TUSB3410 Errata

Figure 1. Suspend Circuit

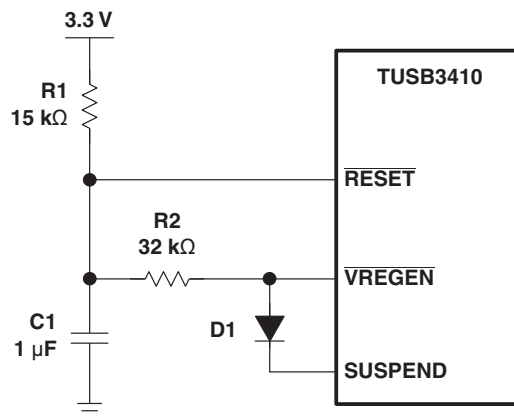
Problem: *The SUSPEND output terminal is sometimes asserted high after power is applied. In bus-powered applications, where SUSPEND is connected to the VREGEN-terminal, the voltage regulator is shut down to meet the USB suspend power requirements. If the external crystal has not had enough time to begin oscillating, the TUSB3410 will not initialize correctly.*

Work Around: See [Figure 1](#) for workaround circuit. More details are provided in the TUSB3410 data sheet ([SLLS519](#)). The added components are R2 and D1.
